SNYDER'S HOLLOW SUBDIVISION, **RESUBDIVISION OF LOT 1**

APPLICATION NUMBER 10 DATE May 15, 2008

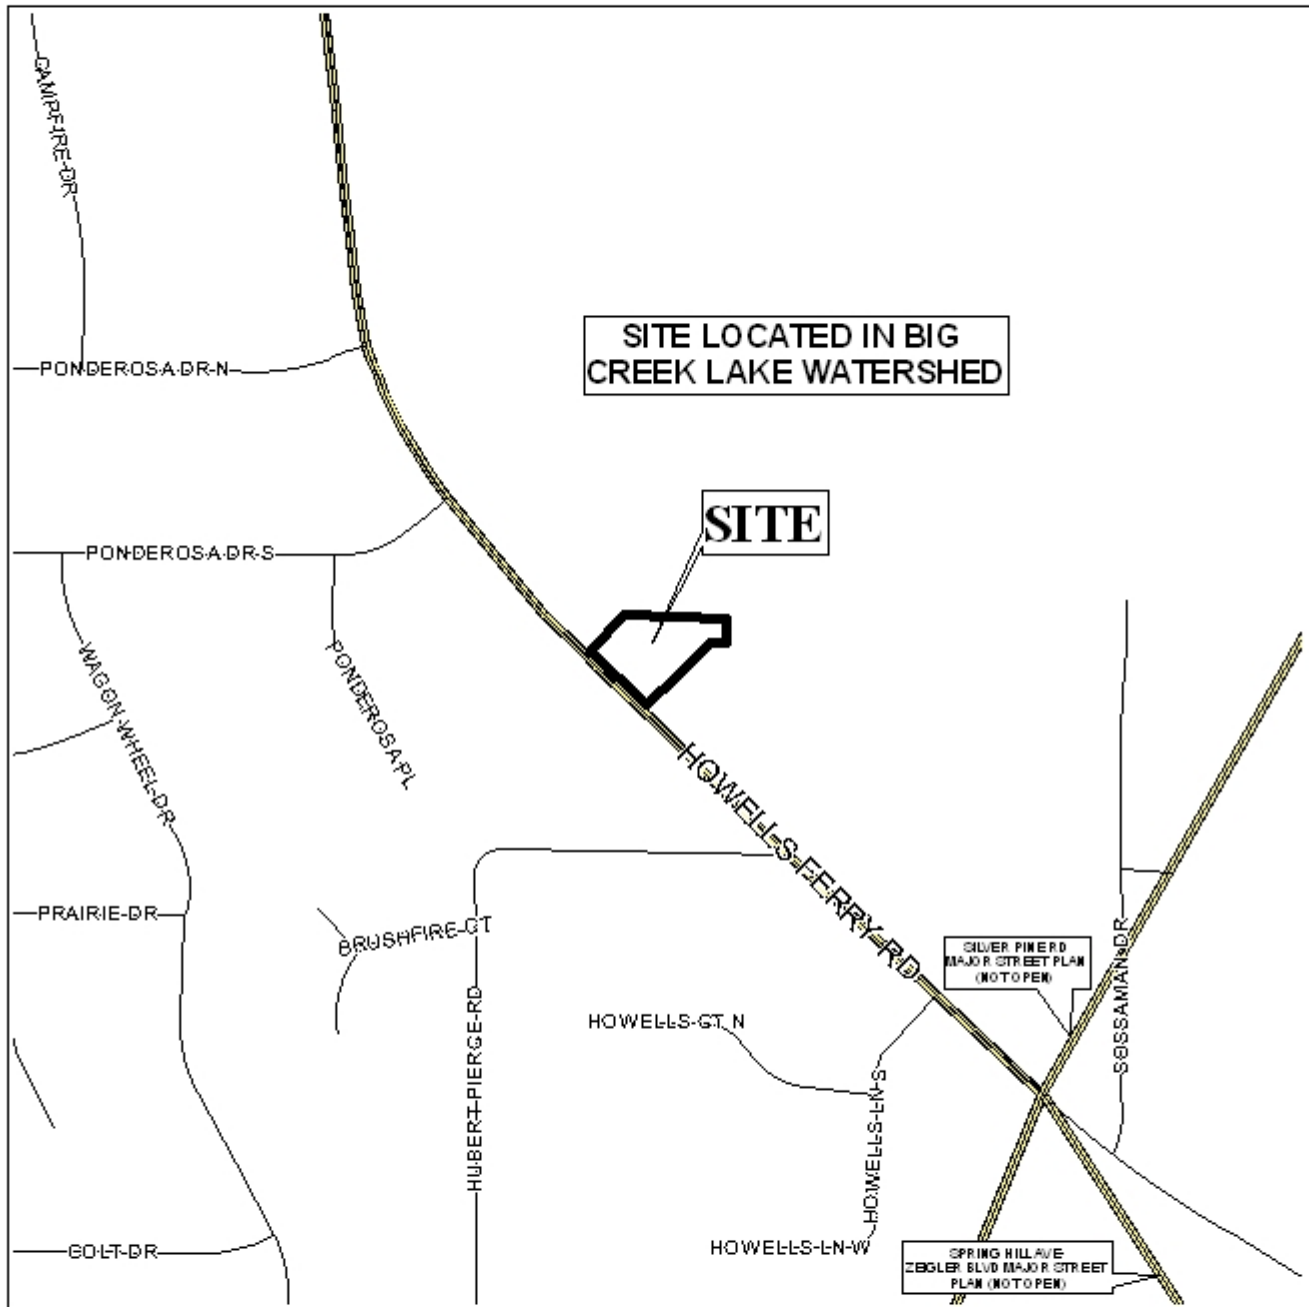
The plat illustrates the proposed 2 lot, 1.1 ± acres subdivision located on the North side of Howells Ferry Road, 580'± West of the North terminus of Hubert Pierce Road. The applicant states that the subdivision is served by public water and individual septic systems.

The site fronts on Howells Ferry Road with a current 80' right-of-way width. Howells Ferry Road is a component of the Major Street Plan with a planned 100' right-of-way width, therefore, the current width is 10' substandard along the site's frontage. Since dedication was not required in the approval of Snyder's Hollow Subdivision in 2003, it should not be required in this case. The plat illustrates a 35' building setback line as measured from the current right-of-way. This would allow a 25' building setback line as measured from the future right-of-way as proposed in the Major Street Plan, and this should also be indicated on the final plat. As a means of access management, a note should be placed on the final plat stating that each lot is limited to one curb cut to Howells Ferry Road, with the size, location and design to be approved by County Engineering and conform to AASHTO standards.

Each lot is labeled with its size in acres and square feet and this should also be done on the final plat, or a table should be provided on the plat furnishing the same information.

- 1) illustration of the 35’ minimum building setback line from the current right-of-way, as on the revised plat submitted with the application;
- 2) placement of a note on the final plat stating that each lot is limited to one curb cut to Howells Ferry Road, with the size, location and design to be approved by County Engineering and conform to AASHTO standards;

- 3) labeling of each lot with its size in square feet and acres, or the provision of a table on the plat furnishing the same information;
- 4) provision of a minimum detention capacity to accommodate the volume of a 50 year post development storm, with a maximum release rate equivalent to the 10 year storm pre-development rate. A licensed Professional Engineer must certify that the design of the Subdivision and its storm water detention features are designed in accord with these requirements. Any storm water detention facility must be shown in the plans and on the recorded subdivision plat as common area not maintained by the City of Mobile, Mobile County or the State of Alabama.” Certification is to be submitted to the Planning Section of Urban Development and County Engineering;
